PLANNING REPORT

Planning & Zoning Commission

9341 Jerome Road– INFORMAL REVIEW

Agenda Item	1
Case Number	17-053 INF
Proposal	Develop 19 single-family lots with one existing lot, on 8.6-acres acres and a proposed density of 2.3 units/acre on a site located off Jerome Road.
Request	Informal review and non-binding feedback of a proposal prior to a formal application.
Location	South side of Jerome Road near the intersection with Corazon Drive.
Applicant	Daniel and Melissa Lorenz, Landowners
Case Manager	Lori Burchett, AICP, Planner II (614) 410-4656 lburchett@dublin.oh.us
Recommendation	Planning recommends the Commission consider this proposal with respect to compatibility with surrounding context, layout, architecture, and site details.

17-053INF
Informal Review
The Hamlet on Jerome
9341, 9351 Jerome Road

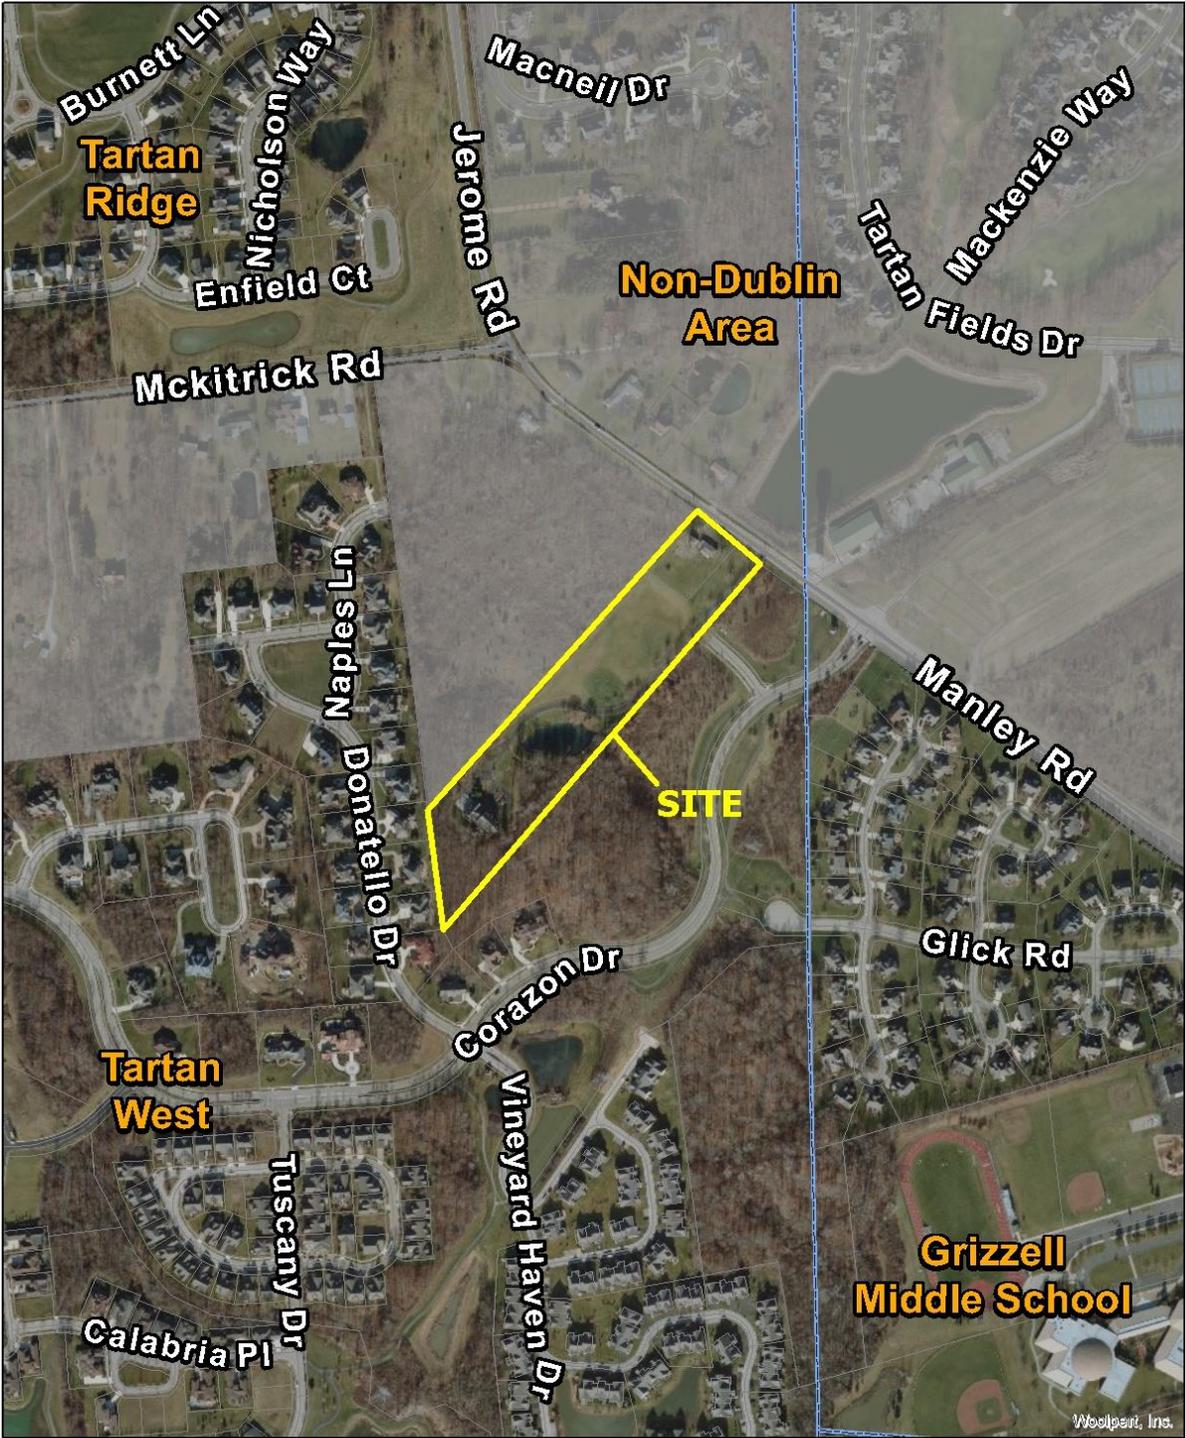
The conceptual proposal is for 20 lots located on 8.6-acres, which results in a density of 2.3 units per acre. Dublin’s Future Land Use Map recommends a density range of 1.5 units per acre, which would permit a maximum of 13 lots on this site. The application materials include a typical lot layout, which shows the anticipated building footprint and outdoor amenities. Lot coverage for this type of development pattern appears to exceed the Code limit of 45%. However, empty-nester type

Traffic & Access and Stormwater Management	<p>The proposal will require rezoning of the property to accommodate the proposed development. At that time, a full traffic study and stormwater report are required to be submitted to the City for review. At this stage, the plans do not include stormwater management facilities or sidewalks.</p>

Analysis		Informal
General	<p>Planning recommends the Commission consider this proposal with respect to the proposed density, architectural concept, signs and compatibility with surrounding development. The following analysis provides additional details.</p>	
<p>Density <i>Discussion Questions</i> 1. <i>Is the proposed land use and overall density appropriate?</i></p>	<p>The proposed land use is consistent with adjacent residential uses and the type of use (Suburban/Rural Residential) shown in the Community Plan. The maximum density in the Community Plan for the Suburban/Rural Residential category is one unit per acre. The surrounding neighborhoods have an average density of less than 2 units per acre.</p> <p>As proposed, 20 total units for the 8.6-acre site is 2.3 units per acre, exceeding the Community Plan recommendation.</p> <p>While there have been discussions at City Council regarding additional housing options for the empty-nester market and the Community Plan Land Use Principles speak to the creation of a wider range of housing choices, the Plan also speaks to the preservation of rural character in certain areas of the community.</p>

Analysis	Informal
<p>2. <i>Is the proposal appropriate to the character of the surrounding development pattern?</i></p>	<p>The surrounding development includes Classic American architecture with a palette consisting of Colonial Revival, English Manor, French, Italian Revival, Neoclassical, Tuscan, and Shingle. Based on the proposed architecture in this development, are the architectural elements (including window design, rooflines, and materials) compatible with the existing character of the surrounding neighborhoods? The development proposes small lots with significant lot coverage.</p>
<p>3. <i>Does the common open space provide a functional and usable space for future residents?</i></p>	<p>The site layout depicts a neighborhood scale open space adjacent to Jerome Road. Engineering has noted that the applicant will be required to extend the shared use path south of the property through the property. As proposed access to the shared-use path would be via Corazon Drive.</p>
